TECHNICAL BULLETIN 008

28/12/2005

RENAULT 2.1D, DT, TD / SYNCHRONOUS DRIVE / TENSIONER INFO

FIG. 1

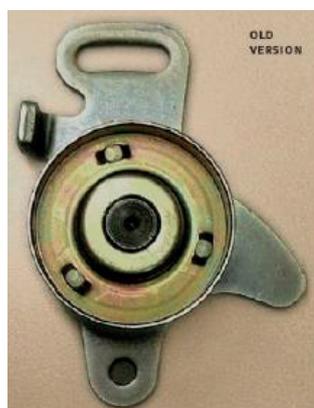
Doing so, we follow Renault OES: the old tensioner (OE ref. 7700722452) (see Fig. 1) is no longer available and has been replaced by a new one (OE ref. 7700871169) (see Fig. 2).

The new tensioner exists out of 2 parts (Fig. 3), which have to be put together as shown in Fig. 2.

The new system is better than the old one, which was spring loaded. Often the spring got blocked and did not push hard enough against the bushing which activates the base plate of the tensioner.

As there is a big visual difference between the old and the new tensioner, some mechanics are not sure how to mount the new part.

1. Remove the old tensioner.
2. Remove the old bushing and spring, these are not needed anymore.
3. Install the new tensioner with the same bolts as the old one.
4. Push the new tensioner against the new belt till properly tensioned, (e.g. you can use a circlips pliers if original tool is not available.
5. Lock the tensioner bolts.
6. Rotate the engine 2 revolutions clockwise.
7. Check the belt tension with Gates STT-1.
8. If the tension is not OK, adjust, rotate 2 revolutions and check again.
